Addendum #3

Request for Proposals for A/E Services

Gray Courthouse Improvements

Issued: April 2, 2025

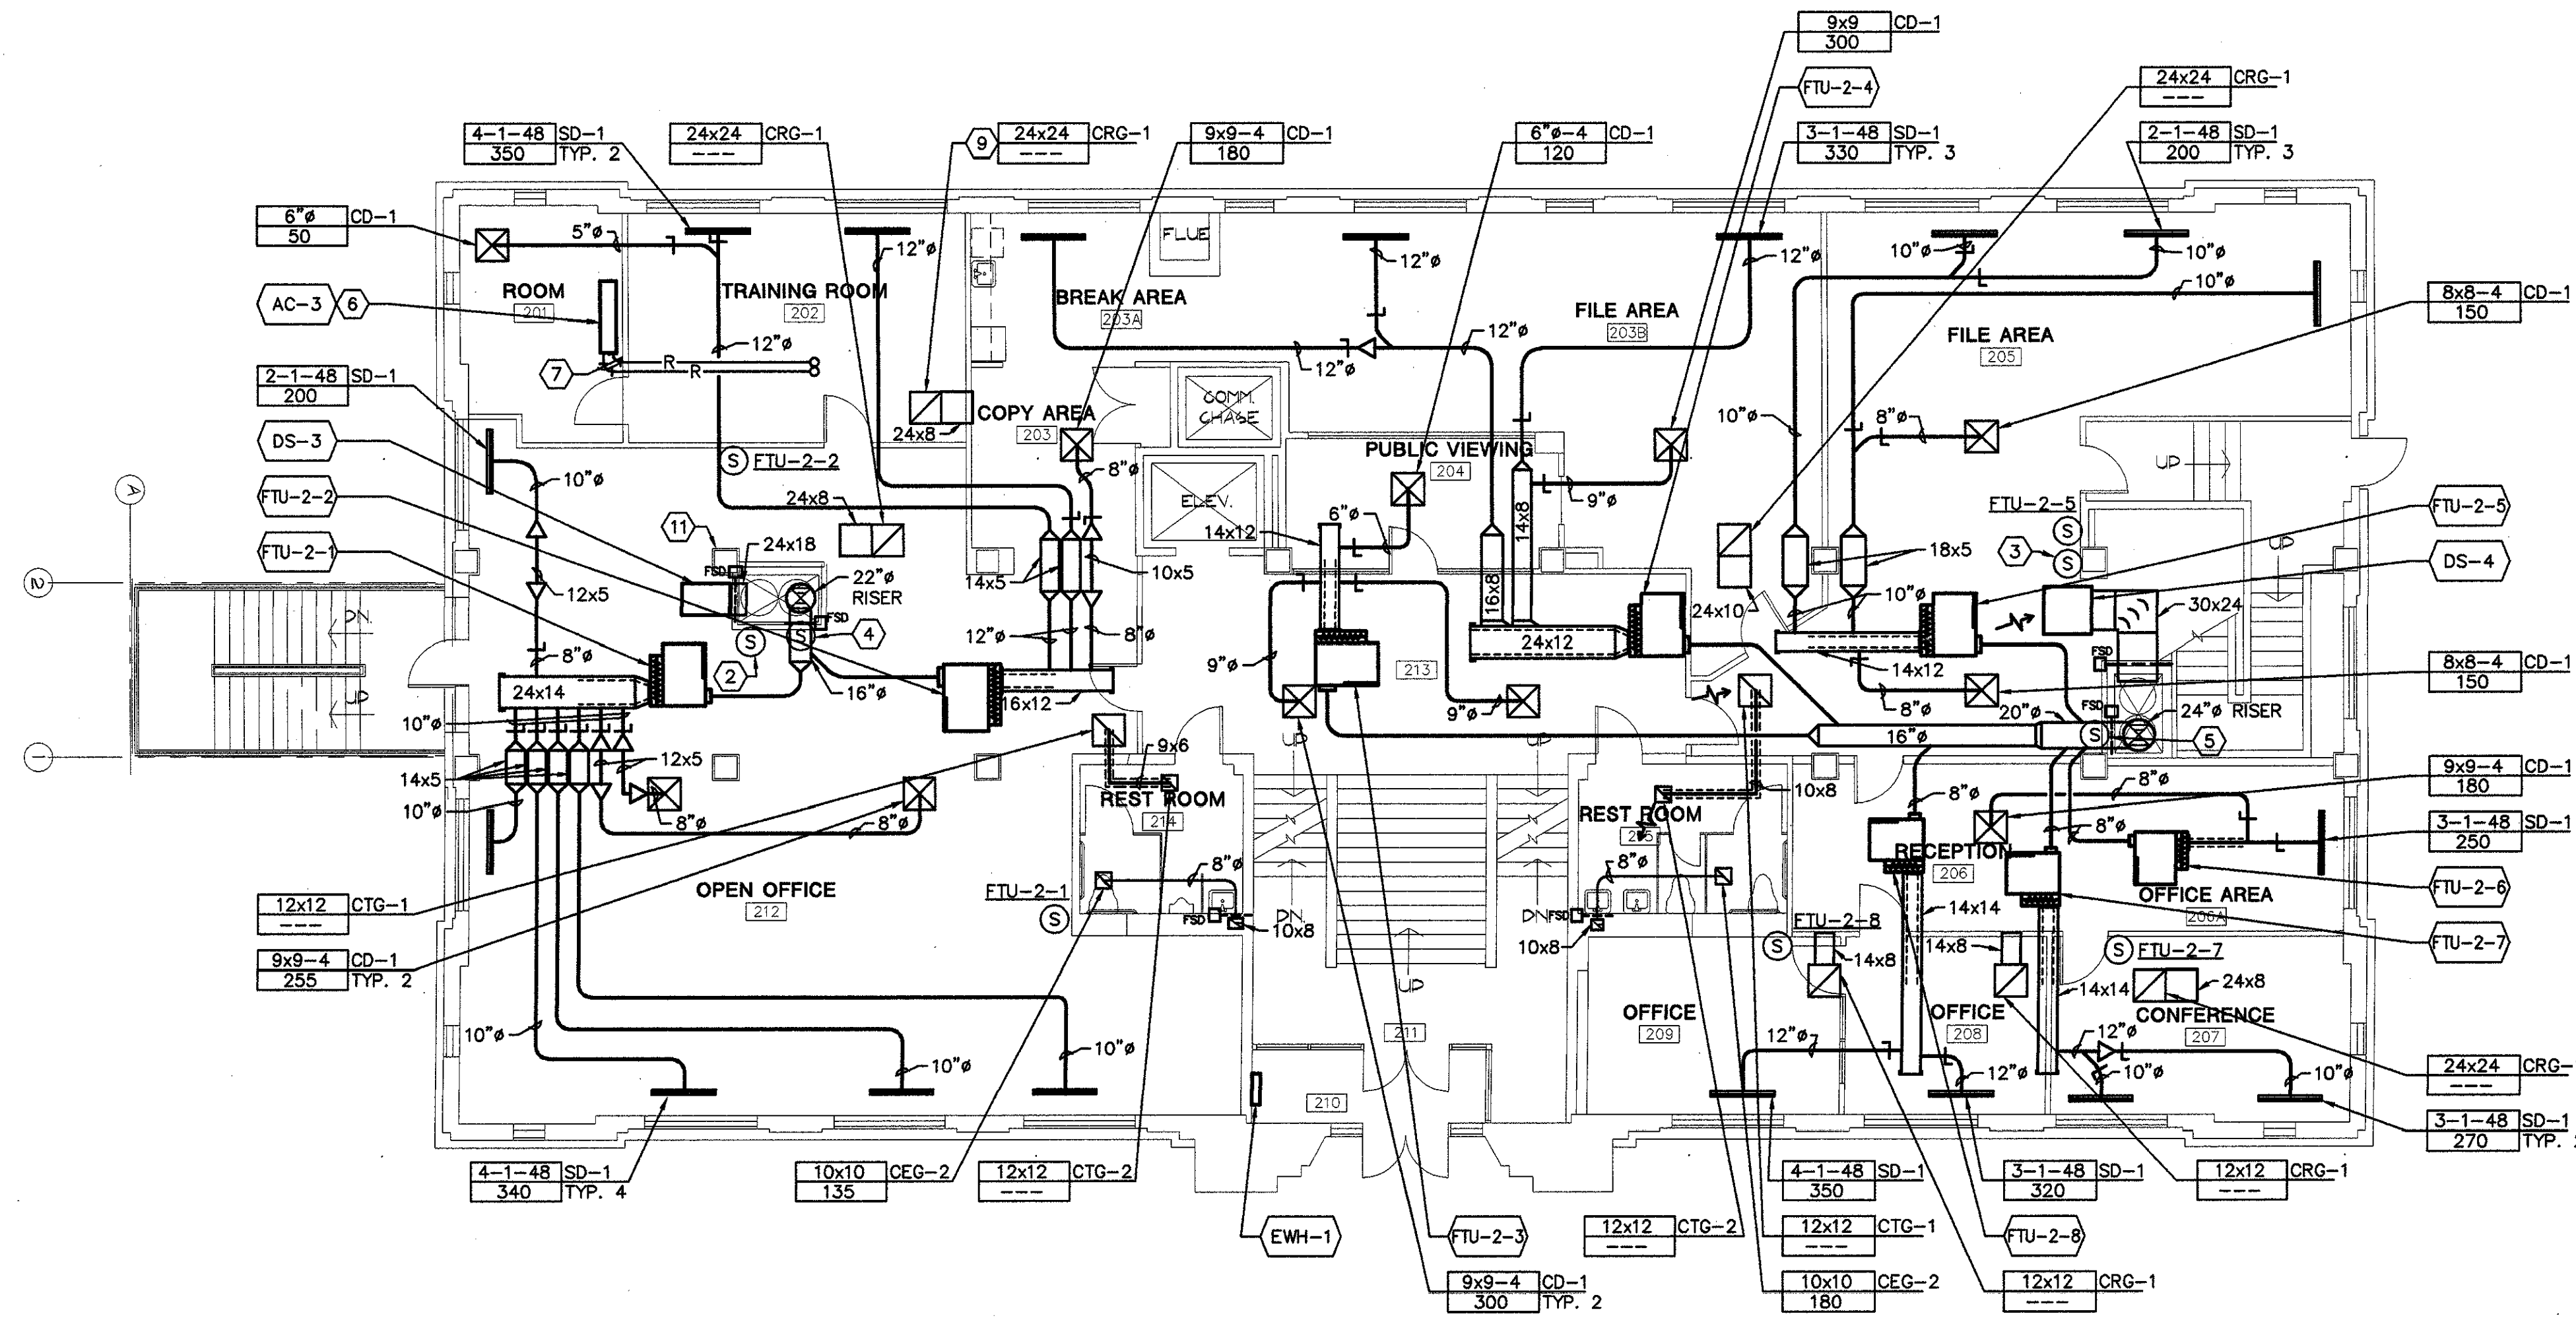
Question #4: The RFP alludes to both rooftop and basement mechanical equipment replacement. Should the design team assume a full mechanical system replacement as part of this scope of work or is some re-use being proposed? Ideally if there's system re-use being proposed, as-builts and a pre-tab would be provided in this RFP. If so, is this information available?

Response: The planned mechanical equipment replacement only includes the rooftop mechanical equipment and ductwork that serves the basement structure on the east side of the building. Please see photo below. This equipment and ductwork need to be removed as part of the roofing replacement on the basement structure and the County is using this as an opportunity to provide a new mechanical system for the basement spaces.

The rooftop equipment on the main roof is not intended to be replaced, although mechanical curbs will likely need to be raised to accommodate new insulation as part of the roofing replacement. Existing ductwork is intended to be re-used except where impacted by the remodel. Mechanical record drawings from a 2005 remodel are included in this addendum and the successful design team will need to verify the as-built conditions. The County will provide a TAB report to the successful design team.

ARCHITECTURAL SITE PLAN

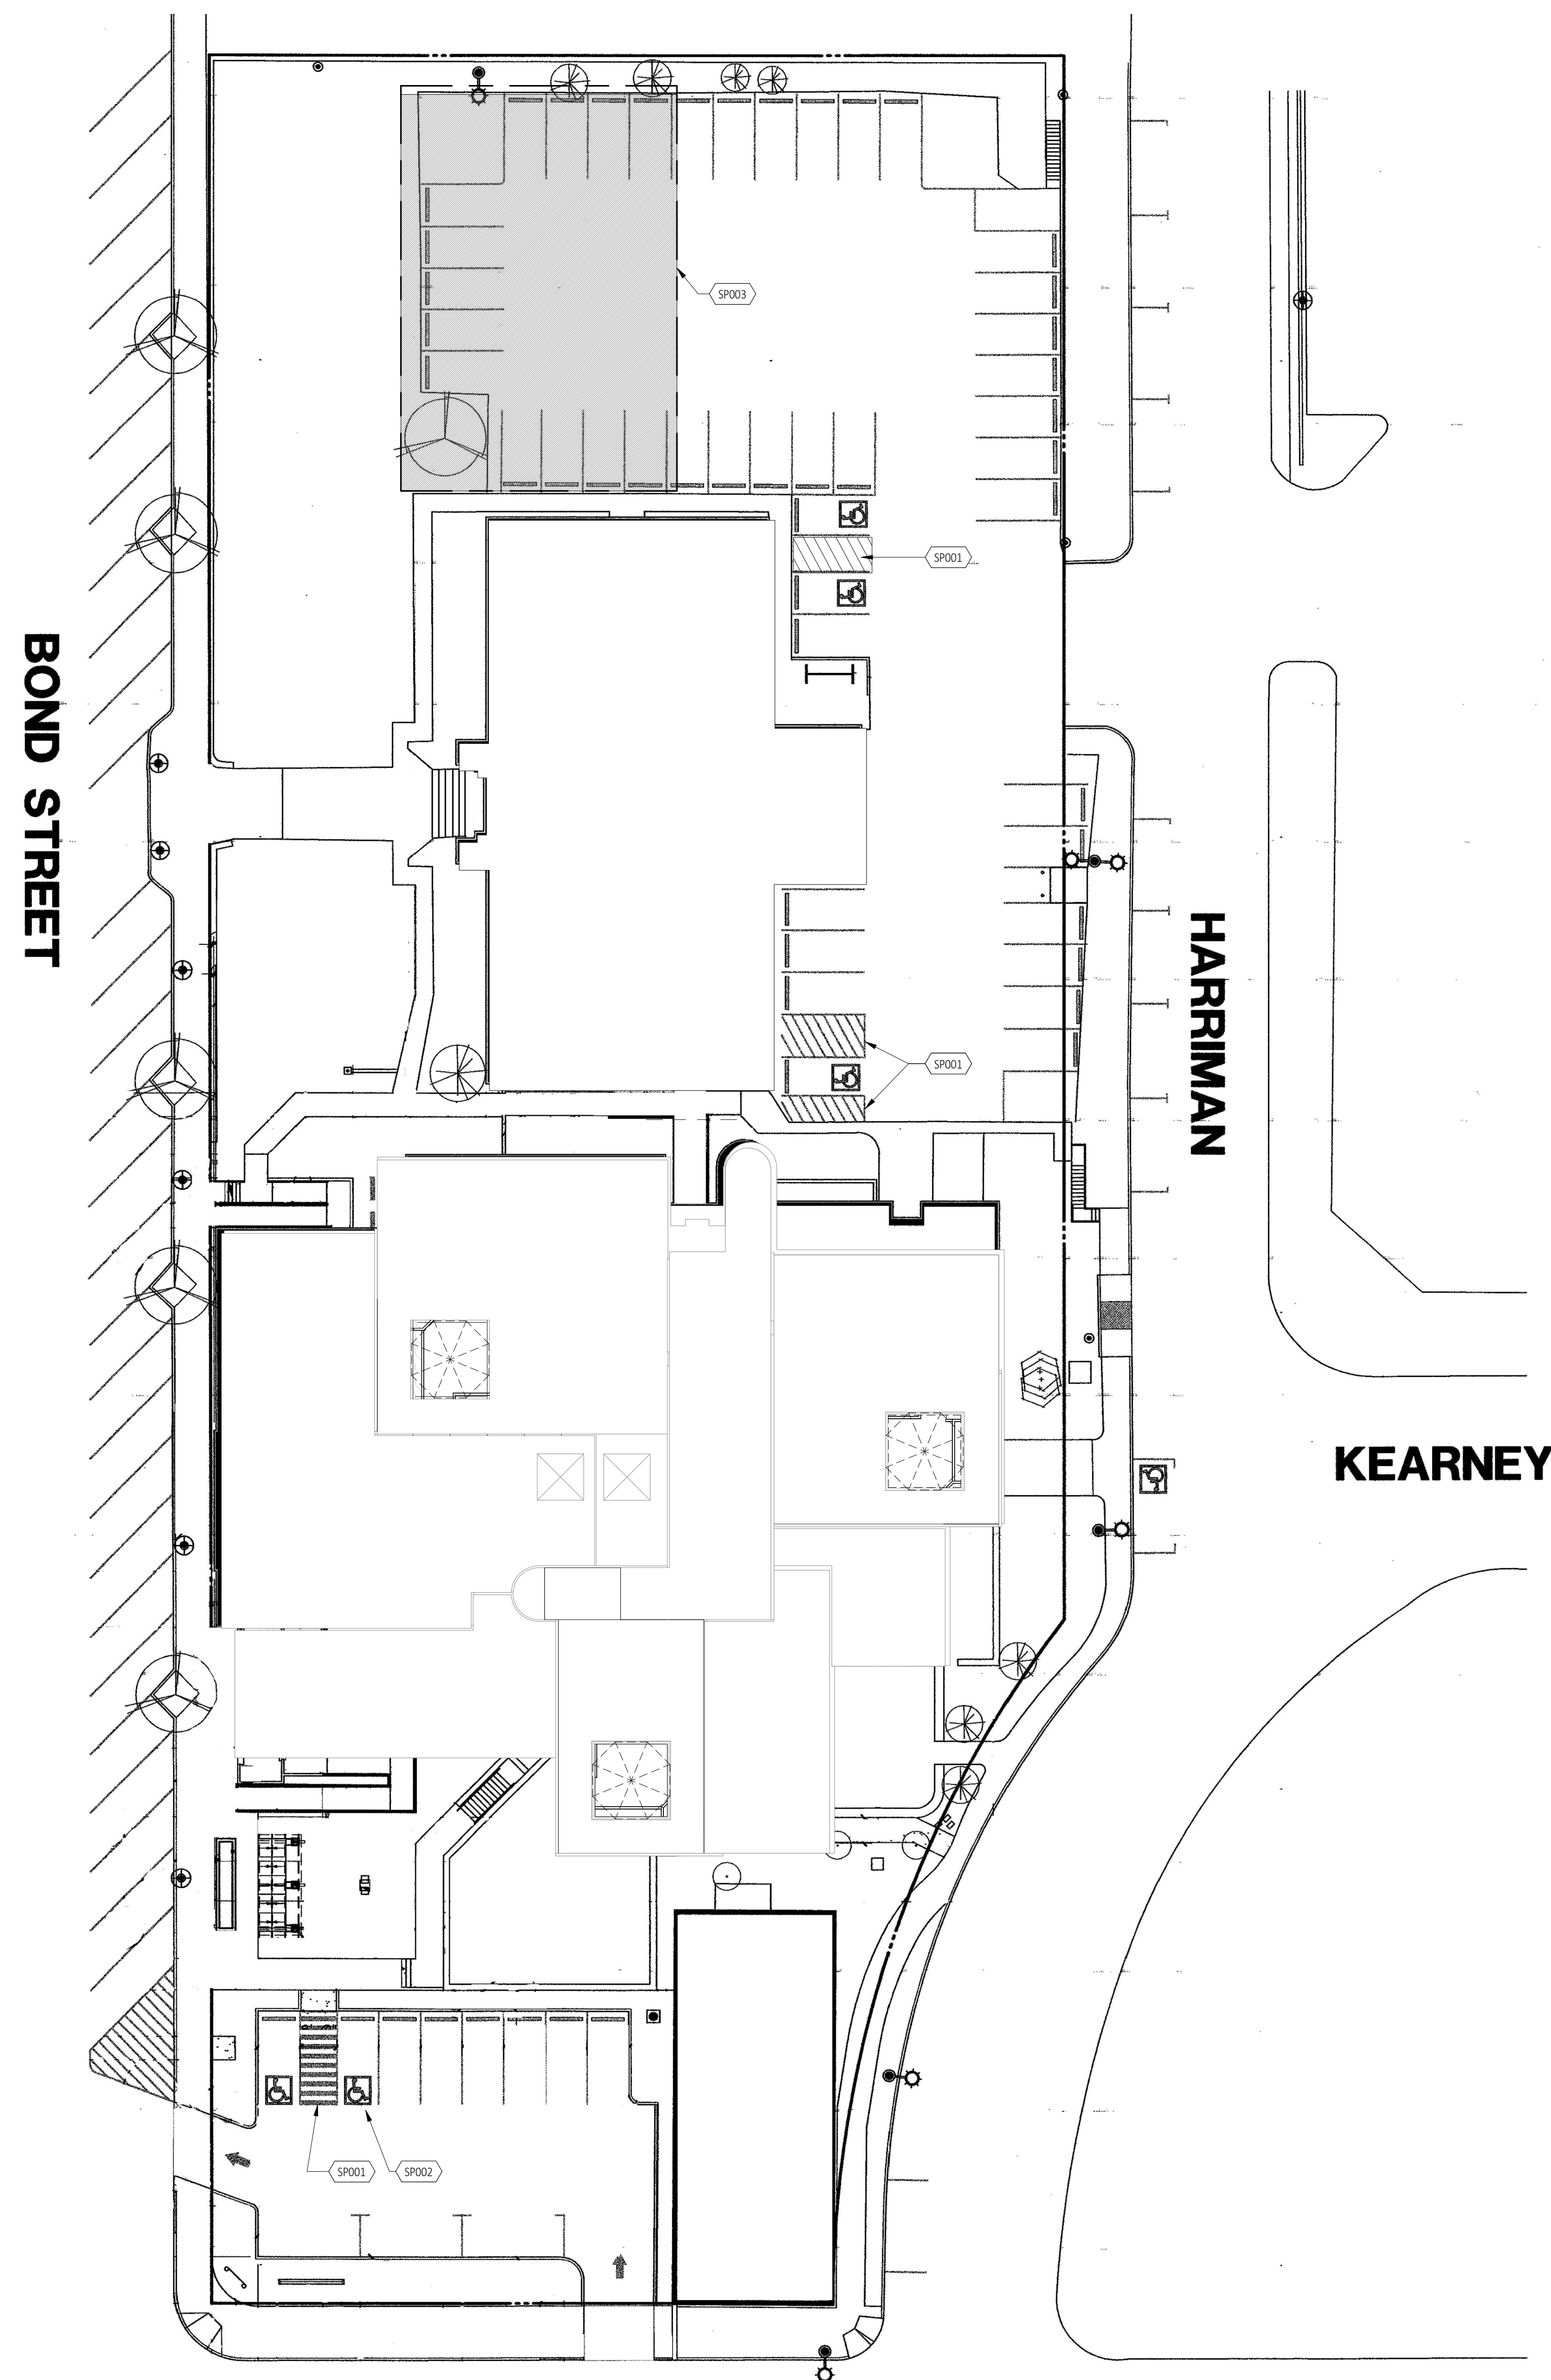
Question #7: Is a site plan available?

Response: Please see the site plan attached to this addendum. The site plan does not include the ground floor connection between the two courthouse buildings shown on the attached floor plan. A topographic survey of the parking lot will be provided to the successful design team.
